Author Reply to Referee 1_Third Round

Theory of the generalized chloride mass balance method for recharge estimation in groundwater basins characterised by point and diffuse recharge

By N. Somaratne and K. R. J. Smettem

Figure 26. Recent stratigraphic assessment in the vicinity of the Blue Lake (Lawson and Hill, in press).

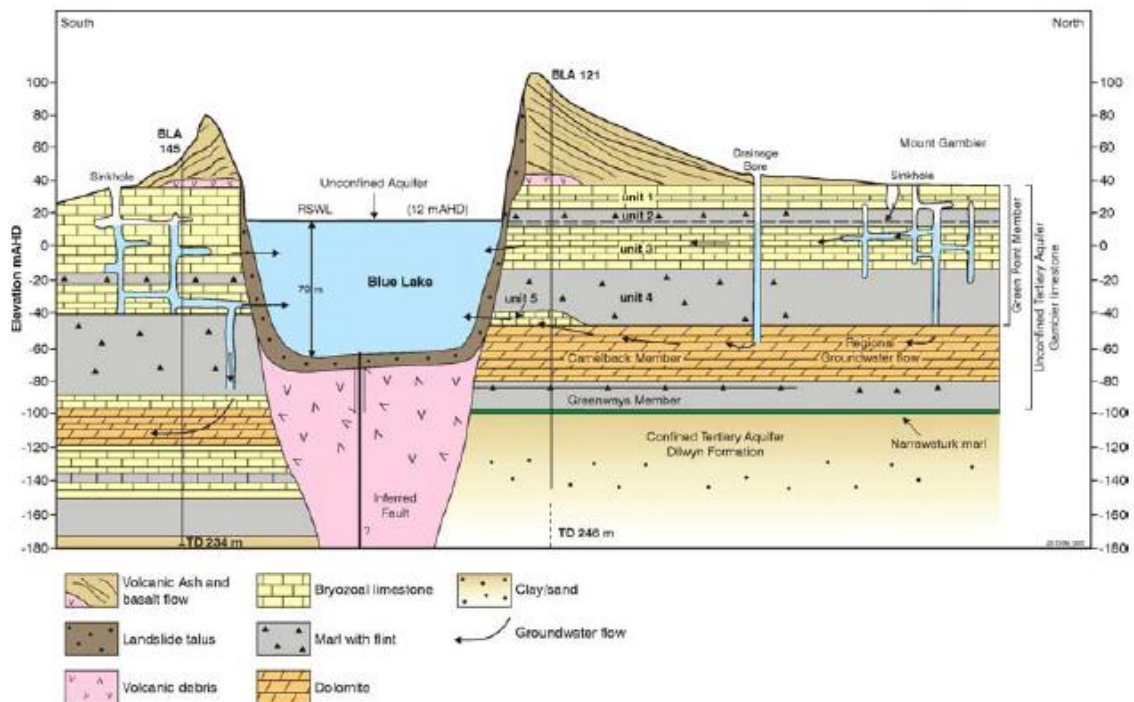
Referee 1-C3: Somaratne and Smettem ignore groundwater flow patterns, and are basing their investigation entirely on Cl distributions. Flow in the SE of South Australia, around Blue Lake, is regionally in somewhat of a south-south-westerly direction. Flow at the boundaries of Uley South is driven by inflows from other carbonate basins to the north. Any groundwater bubbles will move with the groundwater flow, and mix with both recharging water and water from elsewhere. Mixing and groundwater flow together violate the

Chloride values in wells on the south side of the Blue Lake are absolutely not affected from point recharge through drainage wells or sinkholes for two reasons.

1. The Blue Lake water level is 0.1 m lower than the surrounding aquifer water levels. Therefore the aquifer water flows into the Blue lake (opposite direction to the regional flow) from surrounding. Please see the Figure on Page 5.
2. There is a major displacement of aquifer sub-units across the Blue Lake due to faulting. Therefore there is no continuity of the sub-units across the Blue Lake.

Therefore, in the case of the Blue Lake, all diffuse recharge zone wells only capture 'chloride from diffuse recharge'.
